# Town of Hilton Head Island Regular Design Review Board Meeting

EXTERIOR FACADE RENOVATION | EXISTING AND PROPOSED T J MAXX ENTRANCE ELEVATION

## DESIGN TEAM/DRB COMMENT SHEET

PROJECT NAME: Shelter Cove Exterior Façade Renovation – TJ Maxx      DRB#: DRB-000628-2019

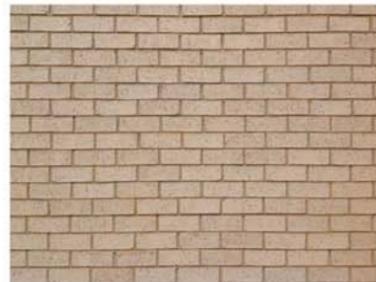
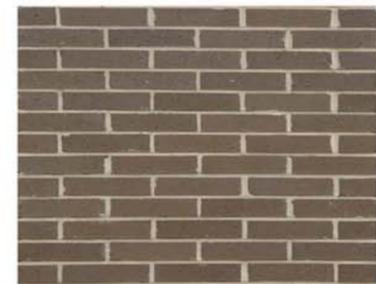
<b><i>APPLICATION MATERIAL</i></b>				
<b>DRB REQUIREMENTS</b>	<b>Complies Yes</b>	<b>No</b>	<b>Not Applicable</b>	<b>Comments or Conditions</b>
Demolition Plan if needed	<input type="checkbox"/>	<input checked="" type="checkbox"/>	<input type="checkbox"/>	Provide plan / elevation of what is being demolished.
Dimensioned Details and of Sections	<input type="checkbox"/>	<input checked="" type="checkbox"/>	<input type="checkbox"/>

<b><i>ARCHITECTURAL DESIGN</i></b>				
<b>DESIGN GUIDE/LMO CRITERIA</b>	<b>Complies Yes</b>	<b>No</b>	<b>Not Applicable</b>	<b>Comments or Conditions</b>
Minimum roof pitch of 6/12	<input type="checkbox"/>	<input checked="" type="checkbox"/>	<input type="checkbox"/>
